**COMMUNITY DEVELOPMENT
DEPARTMENT REPORT**

HEARING DATE: 1/7/2025
TO: Mayor & City Council
FROM: Sonya Allen, Associate Planner
208-884-5533
sallen@meridiantcity.org

SUBJECT: [H-2024-0037](#)
Pollard North - PP, RZ

F. Common Driveway Exhibit

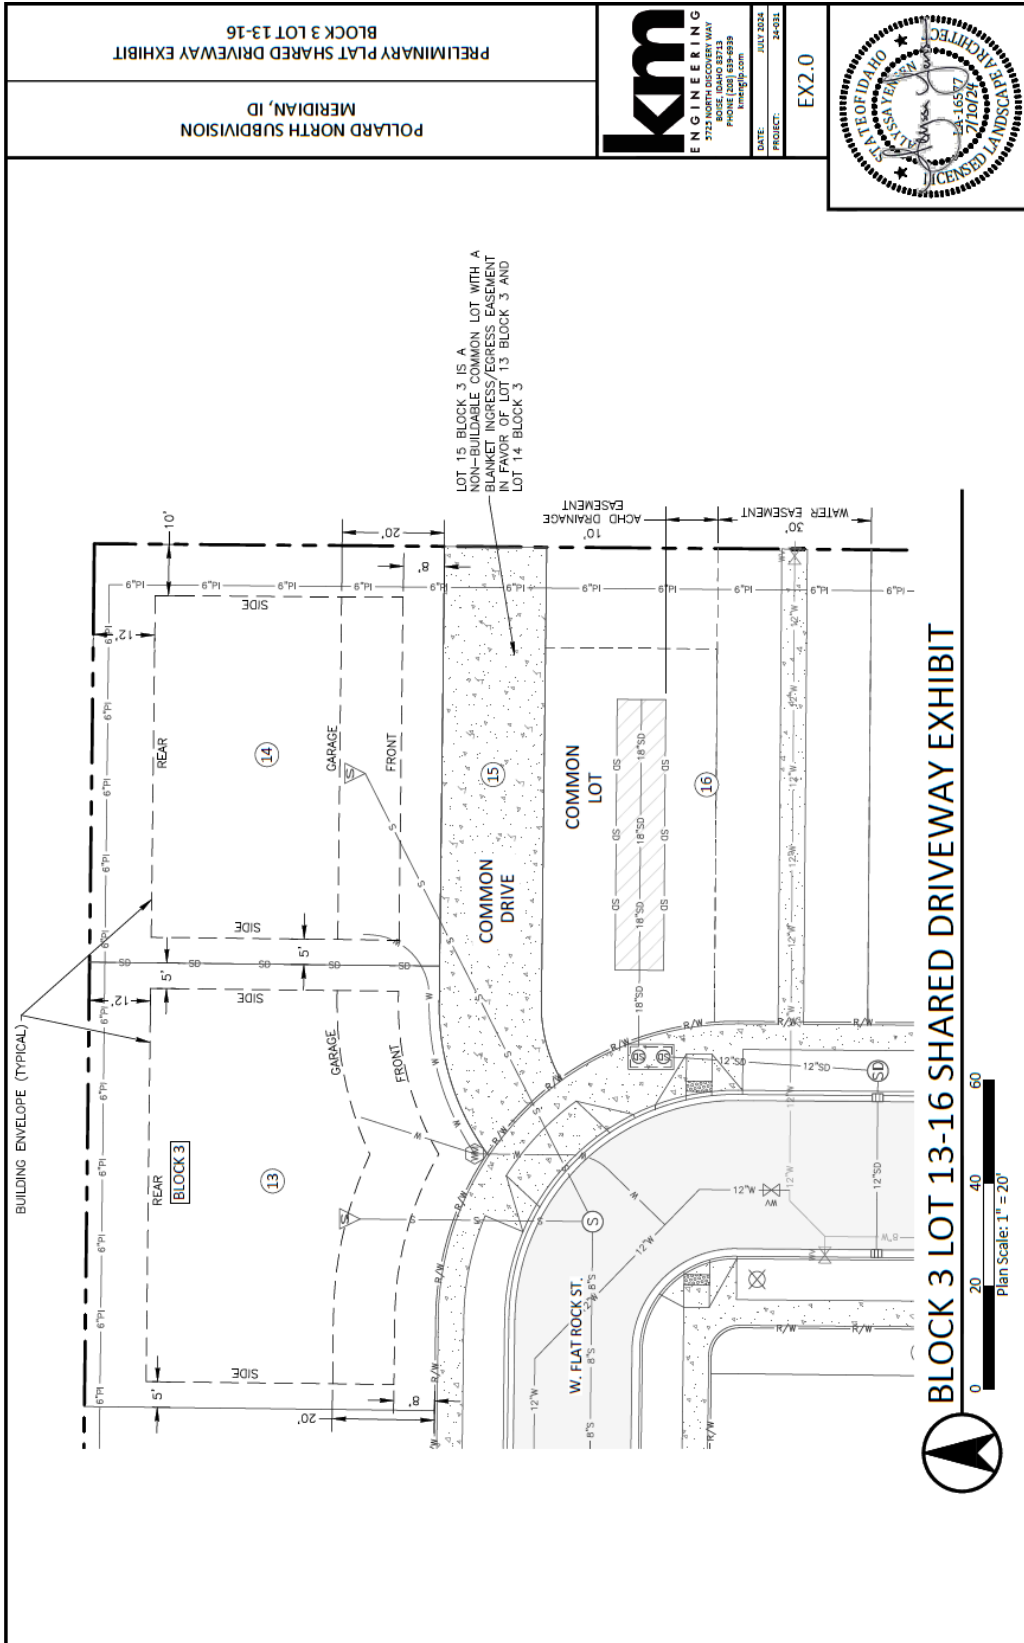
Common driveways: Common driveways are required to comply with the standards listed in UDC 11-6C-3D. One (1) common driveway is proposed on Lot 15, Block 3 for access to Lots 13 and 14. A common driveway exhibit is included in Section VII.F that demonstrates compliance with the standards listed in UDC 11-6C-3D. **Perpetual ingress/egress shall be required either by a recorded easement or as a note on a recorded final plat. The easement or plat note shall include a requirement for maintenance of a paved surface capable of supporting fire vehicles and equipment. Solid fencing adjacent to common driveways is prohibited, unless separated by a minimum five-foot wide landscaped buffer planted with shrubs, lawn or other vegetative**

groundcover – if fencing is proposed along the south side of Lot 15, Block 3, a 5-foot wide buffer should be provided.

- iv. If solid fencing is proposed along the south side of Lot 15, Block 3, a 5-foot wide buffer should be provided planted with shrubs, lawn or other vegetative groundcover as set forth in UDC 11-6C-3D.5. The plat should be adjusted accordingly.

4. The common driveway shall be constructed in accord with the standards listed in UDC 11-6C-3D and per the common driveway exhibit in Section VII.F.
 5. Perpetual ingress/egress shall be required for the common driveway either by a recorded easement or as a note on a recorded final plat as set forth in UDC 11-6C-3D. The easement or plat note shall include a requirement for maintenance of a paved surface capable of supporting fire vehicles and equipment.

G. Landscape Plan (dated: 7/25/24)

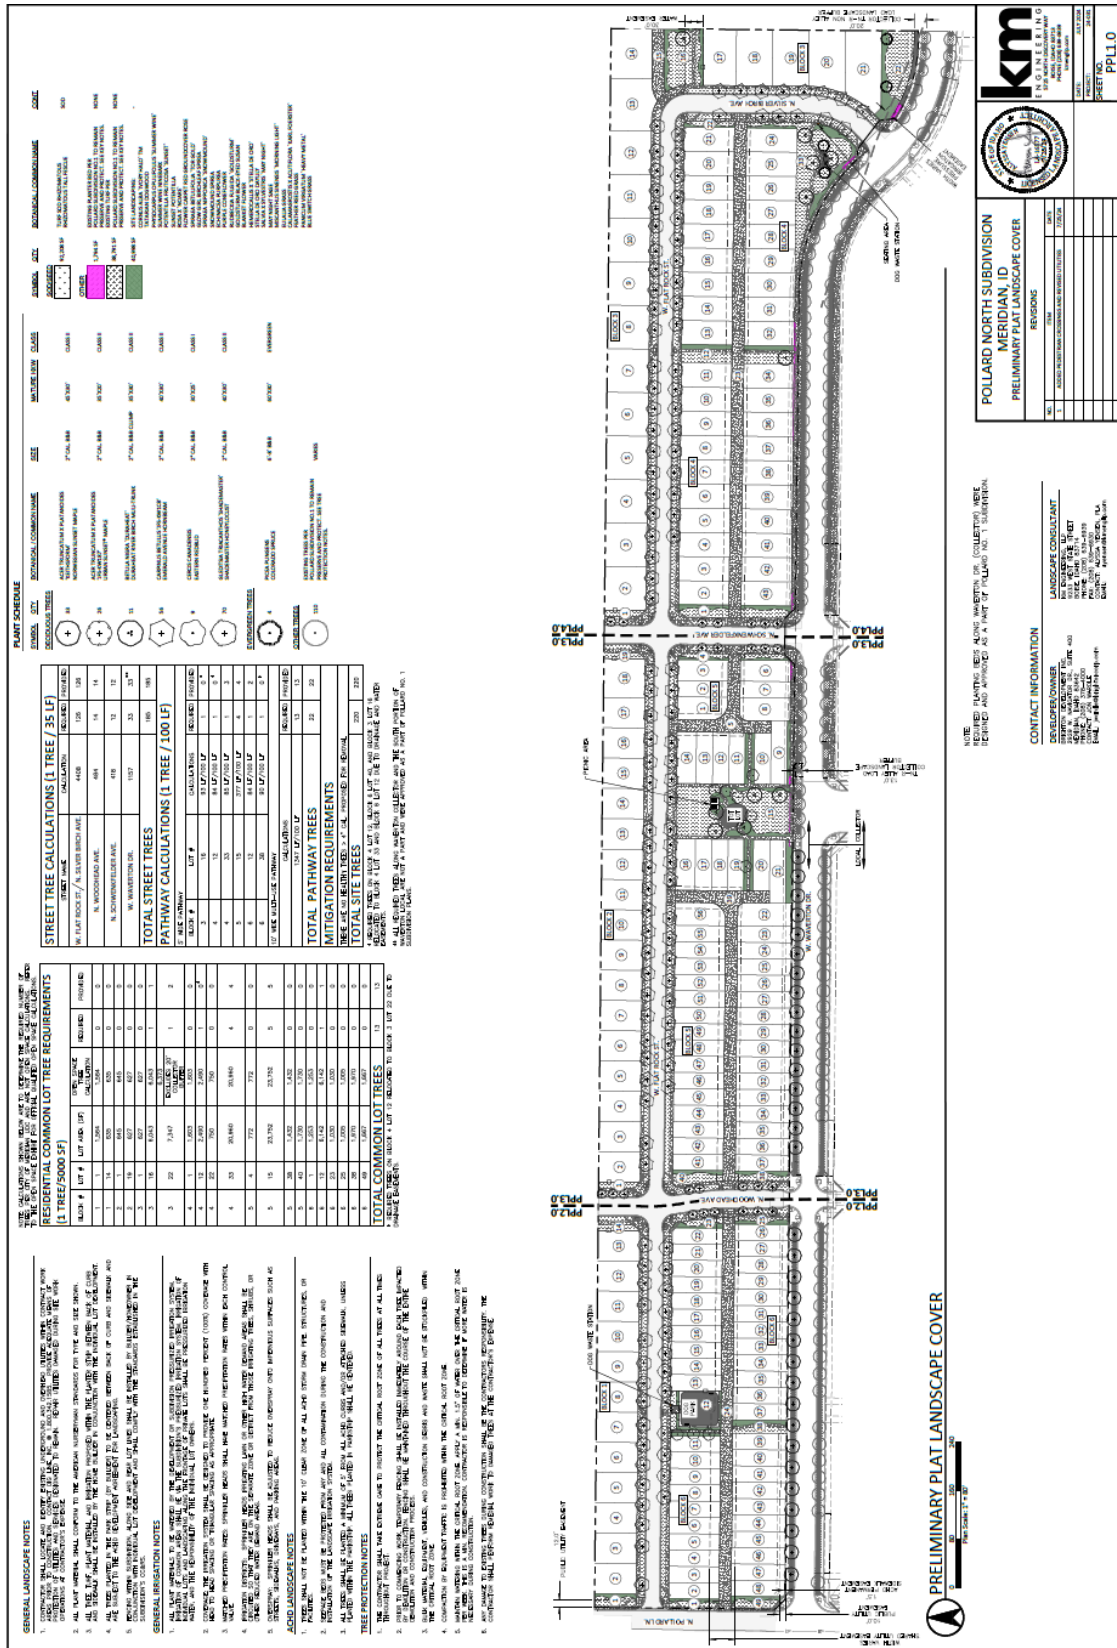
The landscape plan depicts 5-foot tall open vision metal fencing and 6-foot tall closed vision stained cedar fencing on the shared property line of some building and common lots. **The developer is responsible for constructing fences abutting all pathways and common open space lots to distinguish common from private areas. Fencing should be depicted on a revised landscape plan along with a detail of the fencing type proposed; or, alternative compliance may be requested to the standard.**

The pathways along the east and west sides of Lot 15, Block 5 abut the residential property lines and don’t have the required 5-foot of landscaping on both sides of the pathway as set forth in UDC 11-3B-12C. The landscape plan should be revised to comply with these standards; or, a request for alternative compliance may be submitted to this standard as set forth in UDC 11-5B-5.

3. The landscape plan shall include the following revisions:
 - i. Depict a 20-foot wide street buffer along W. Waverton Dr. designated as a collector street, east of N. Levi Ave., with landscaping per the standards listed in UDC 11-3B-7C. Include additional landscaping with calculations that demonstrate compliance with the required standards. The buffer shall also comply with the enhanced buffer requirements listed in UDC 11-3G-3B.3 and because it was counted toward open space requirements. The buffer shall also comply with the enhanced buffer requirements listed in UDC 11-3G-3B.3 because it was counted toward open space requirements.

- ii. Depict fencing abutting pathways and common open space lots to distinguish common from private areas as set forth in UDC 11-3A-7A.7; or, submit a request for alternative compliance to this standard.

- iii. Depict a minimum 5-foot wide landscape strip along both sides of the pathways located along the east and west sides of Lot 15, Block 5 with landscaping in accord with the standards listed in UDC 11-3B-12C; or, submit a request for alternative compliance to this standard as set forth in UDC 11-5B-5.
